**Advanced Passive 1000 (AP1000)
Generic Technical Specification Traveler (GTST)**

Title: Changes Related to LCO 3.6.8, Containment Penetrations

Section 3.6.8, Containment Penetrations

Figure B 3.6.87-1 (page 1 of 1)
Time Prior to Coolant Inventory Boiling

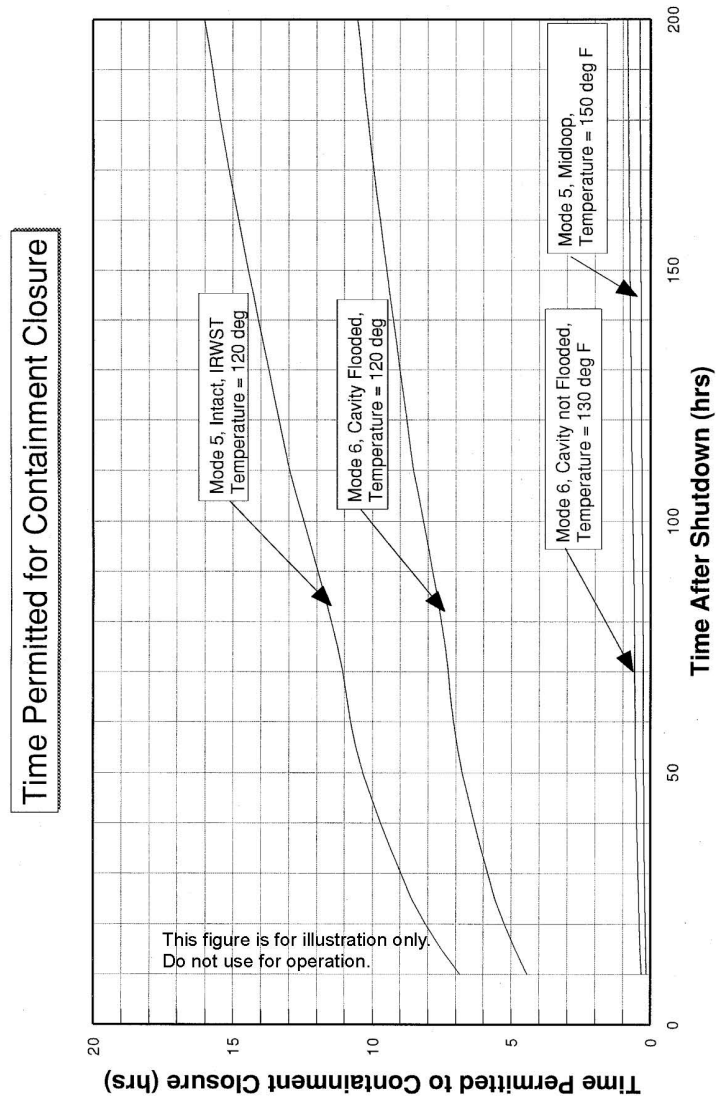
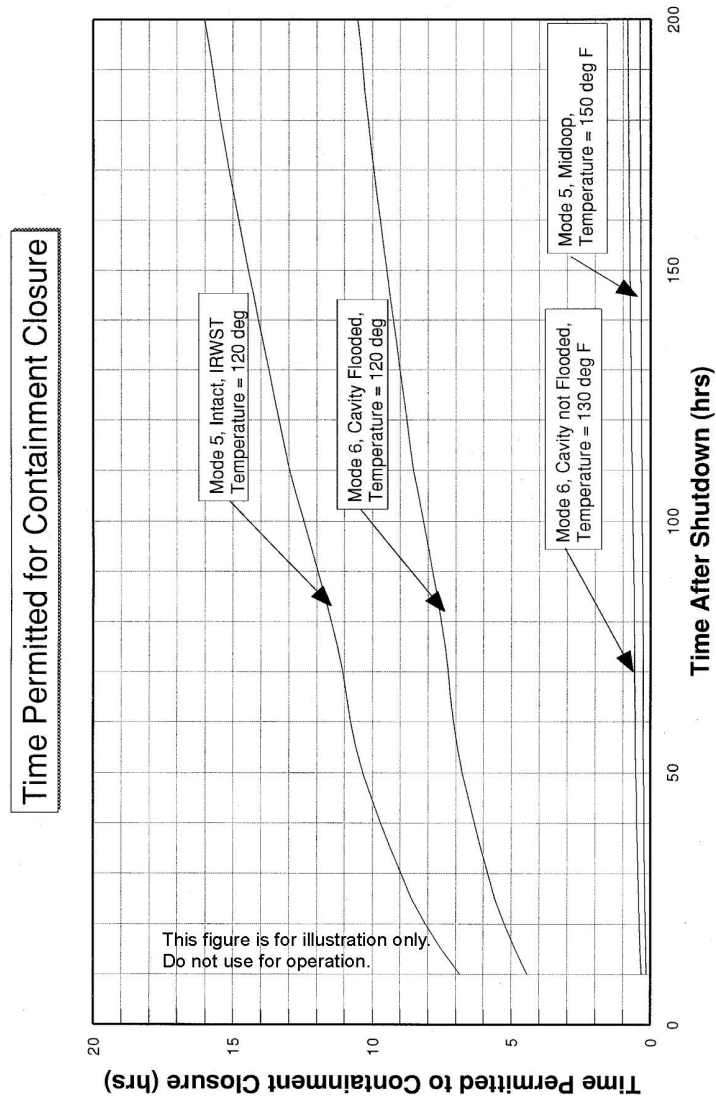
Figure B 3.6.8-1 in the bases is revised by removing brackets from the figure. (COL Item B3.6.8)

VEGP COL Item B3.8.6 removes the brackets from Figure B 3.6.8-1 in the Bases.

VEGP COL Item B3.8.6 removes brackets from Figure B 3.6.8-1 since the figure is for illustration only and should not have been bracketed. VEGP COL Item B3.6.8 (see Reference 2), removal of the Reviewer's Note in B3.6.8 was in error by the applicant. Instead this item was meant to remove the brackets from Figure B 3.6.8-1.

The markup to remove the brackets from figure B 3.6.8-1 was manually done in the Word document.
